# TOWN OF EXETER, NEW HAMPSHIRE

## PUBLIC NOTICE EXETER CONSERVATION COMMISSION

2. Wetland Conditional Use Permit application and Standard Dredge and Fill Wetland Permit Application for the construction of a 95,000 SF Industrial Warehouse building located at 19 Continental Drive Tax Map 47-7-2.

Date: July 8th, 2022  
To: Conservation Commission Board Members  
From: Kristen Murphy, Natural Resource Planner  
Subject: July 12<sup>th</sup> Conservation Commission Meeting

SHEET NUMBER:  
**C - 4**

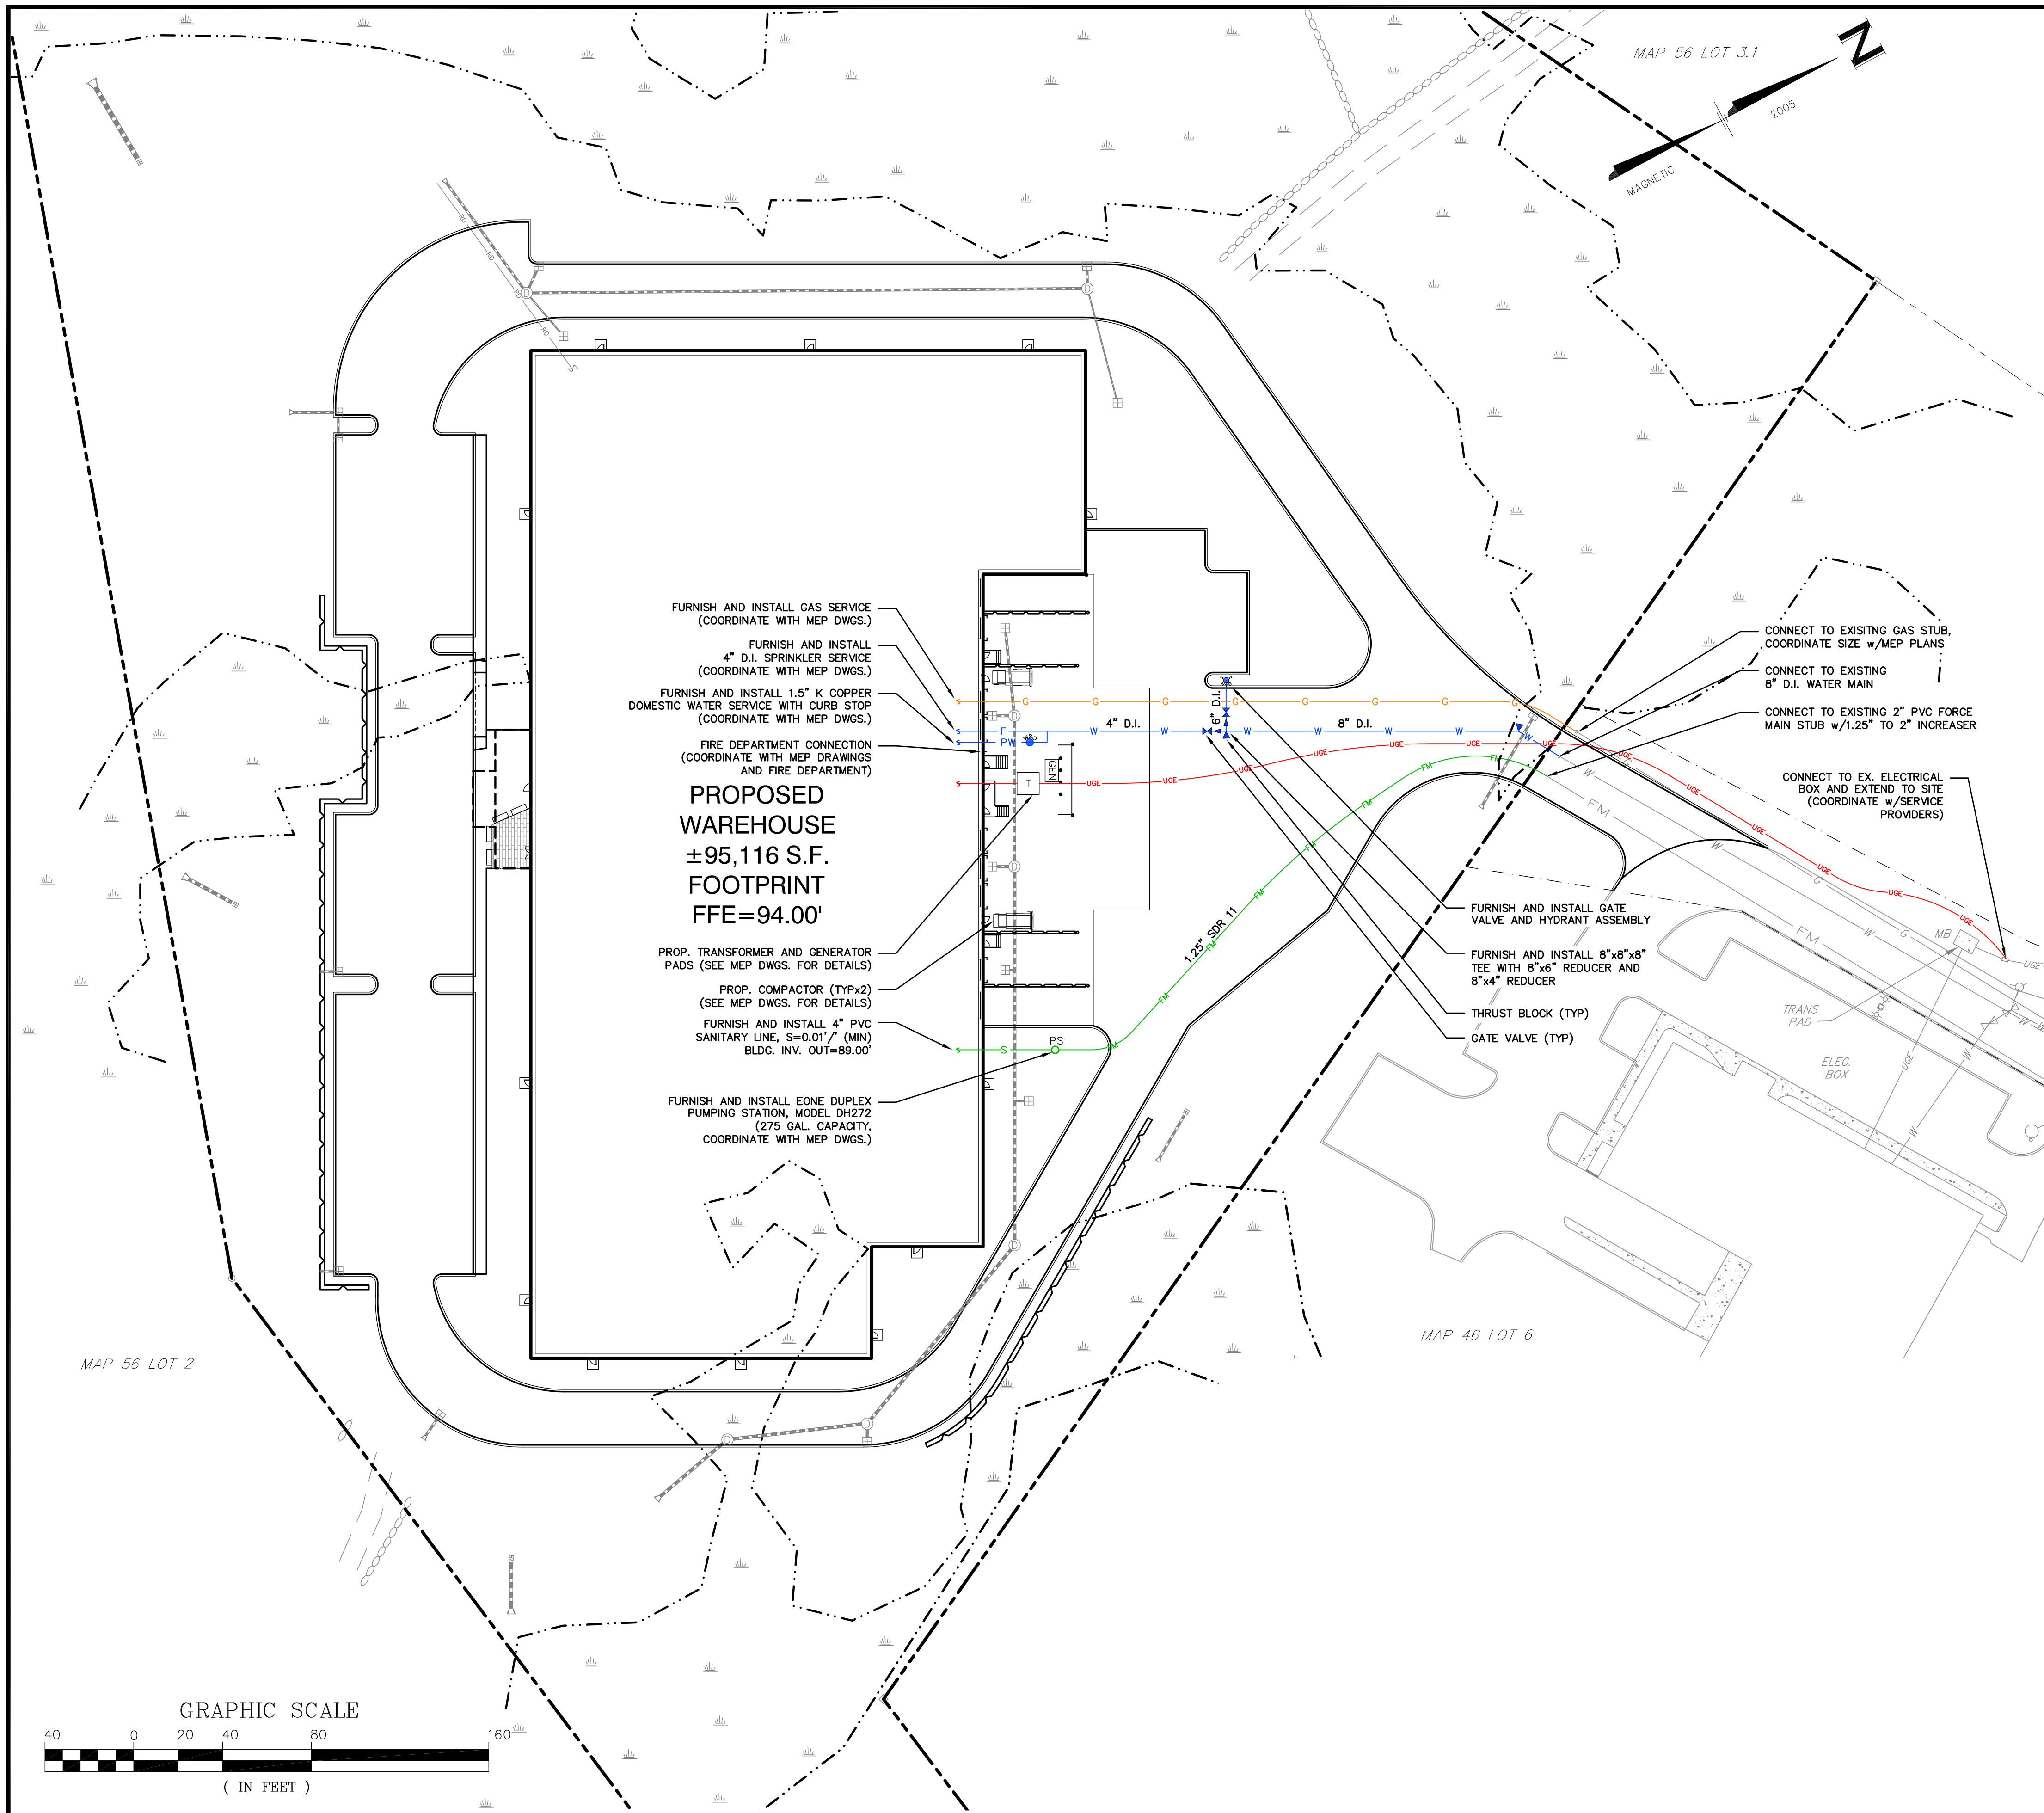
- Please update Sheet C-4 notes to add the May wetland survey dates mentioned in the CUP wetland report. Currently notes only indicate 12/17/21 survey.

- Sheet C-4 depicting buffers has numerous corrections needed. Please refer to 9.1.3.E and show limited use, parking and structure buffers as indicated. Example: vernal pools require 75' limited use buffer and 100' parking and structure setback. Only 75' buffer is shown and it is labeled as 200' buffer. Similar errors for wetland buffers.
